TRACKSIDE GARDENS

WILSON EAST

Town Planning Application - RFI Response

Project Name 110 Wilson Street
Project Number 00013261
Project Address 110 Wilson Street
Moonee Ponds VIC 3039

WE June 21 2pm 1:300

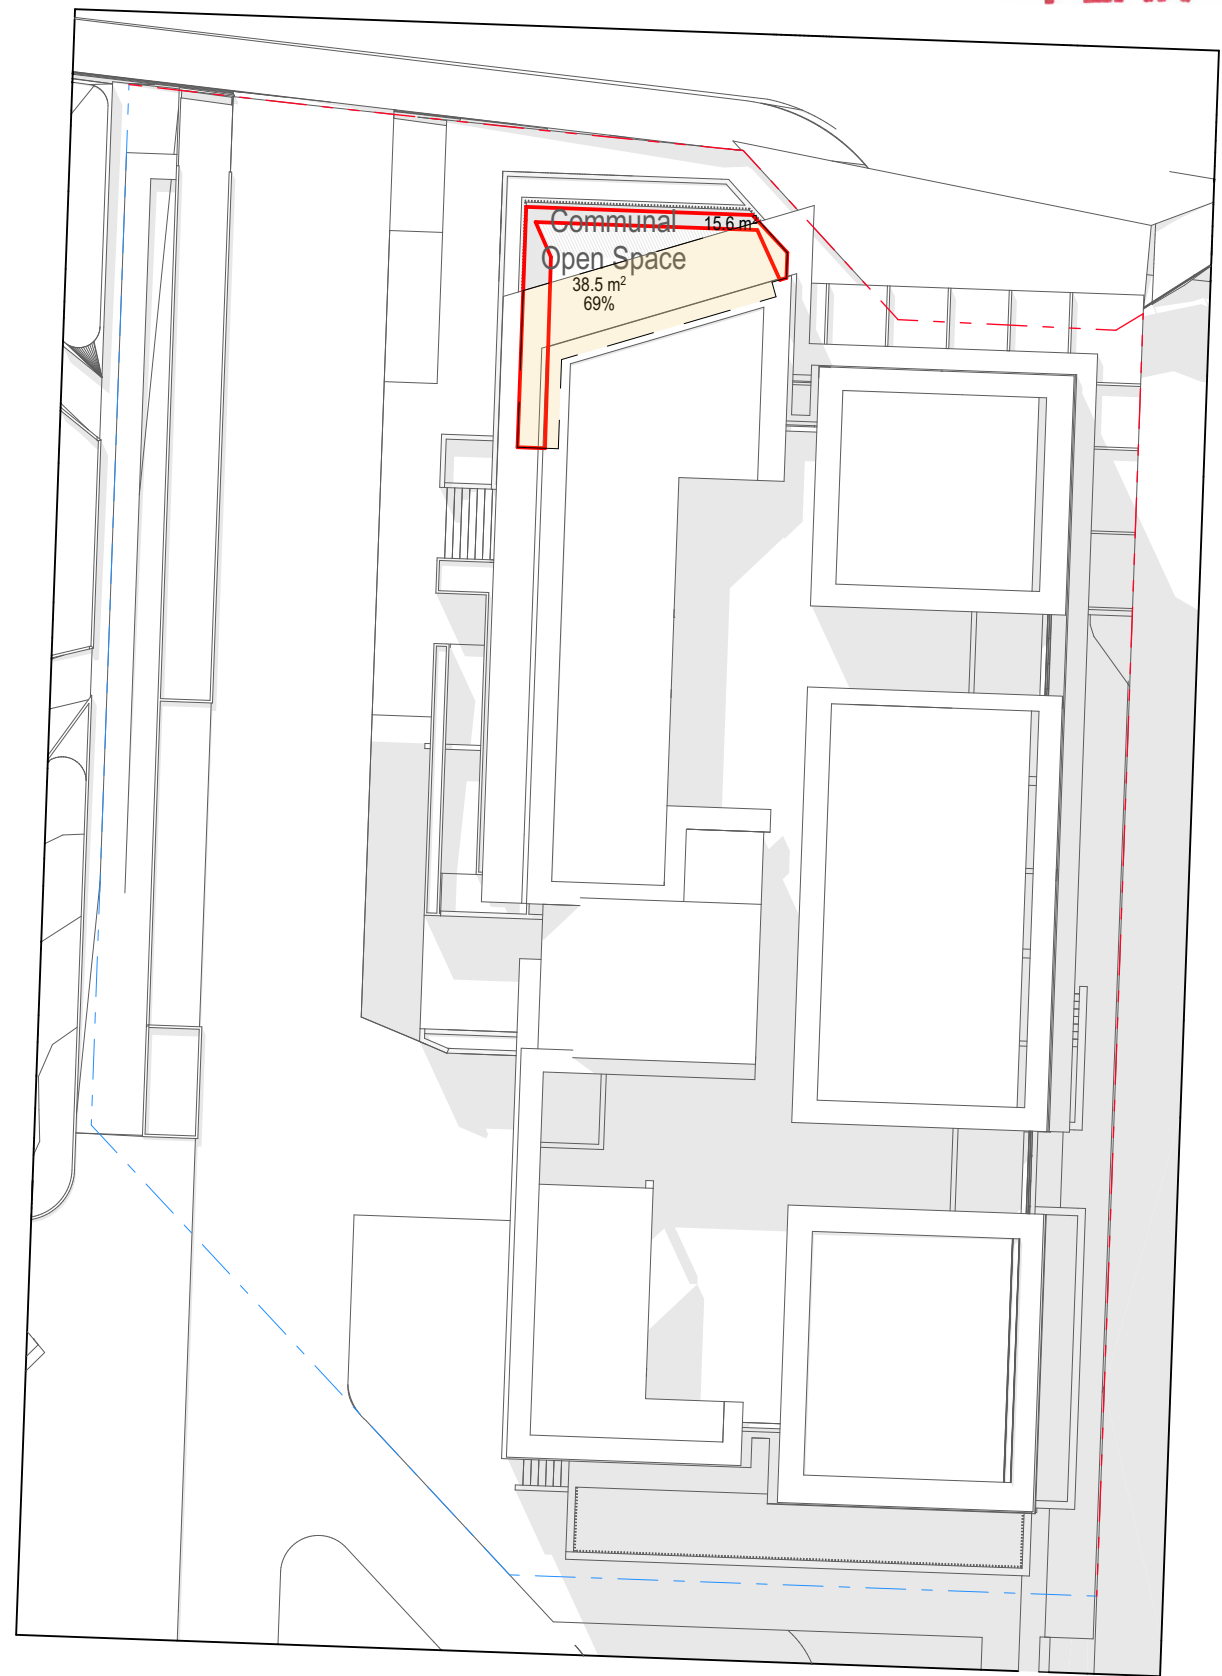
PA2604323 SECTION 54(1) RPI MATTERS
4.
b) All wind mitigation devices required per the recommendations of the Environmental Wind Speed Assessment, including details of materiality, height and cross-sections if necessary.
